Device TC1736
Marking/Step EES-AA, ES-AA, AA
Package PG-LQFP-144-10

01708AERRA

This Errata Sheet describes the deviations from the current user documentation.

Figure 1 Timing concerning equidistant multiple timers

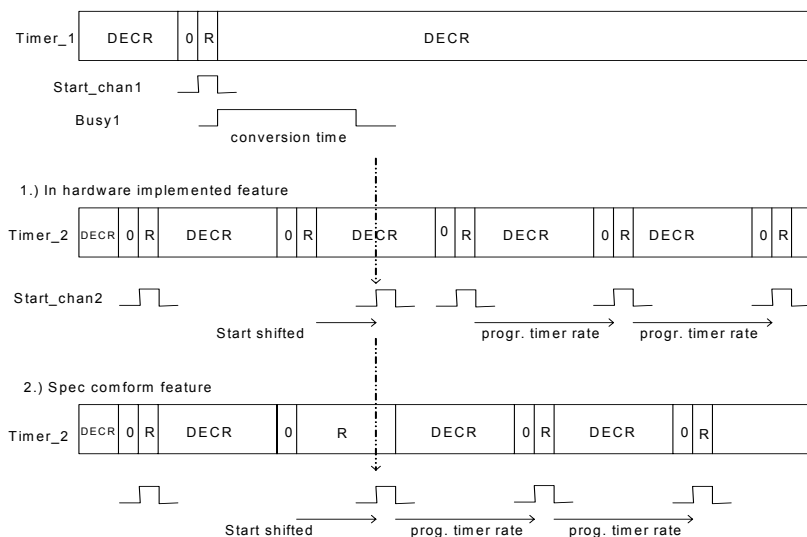
The description is an example for timer_1 and timer_2, but can also affect all other combinations of timers.

Timer_1 and Timer_2 are running with different reload-values. Both timers should start conversions with the requirement of equidistant timing.

Problem description:

Timer_1 becomes zero and starts a conversion. Timer_2 becomes zero during this conversion is running and sets the conversion-request-bit of channel_2. At the end of the conversion for channel_1 this request initiates a start for channel_2. But the Timer_2 is reloaded only when setting the request-bit for channel_2 and is decremented during the conversion of channel_1.

The correct behavior would be a reload when the requested conversion (of channel_2) is started.

Therefore the start of conversion for channel_2 is delayed by maximum one conversion-time. After this delay it will be continued with equidistant conversion-starts. Please refer to the following figure.

Figure 2 Loss of Arbitration

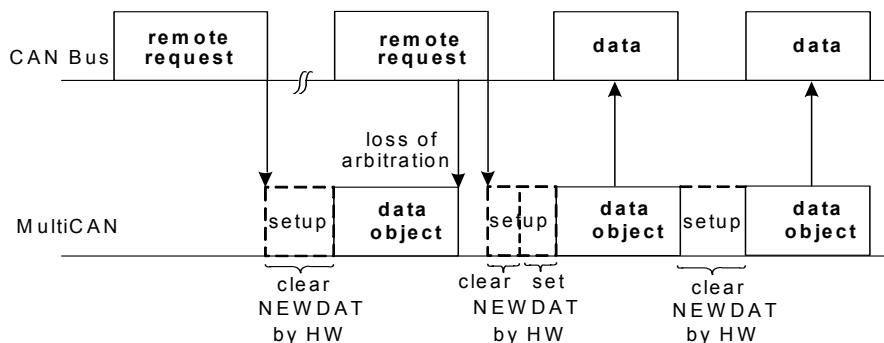
When the appropriate message object (data frame) triggered by the first remote frame wins the arbitration, it will be sent out and `NEWDAT` is not reset. This leads to an additional data frame, that will be sent by this message object (clearing `NEWDAT`).

There will, however, not be more data frames than there are corresponding remote requests.
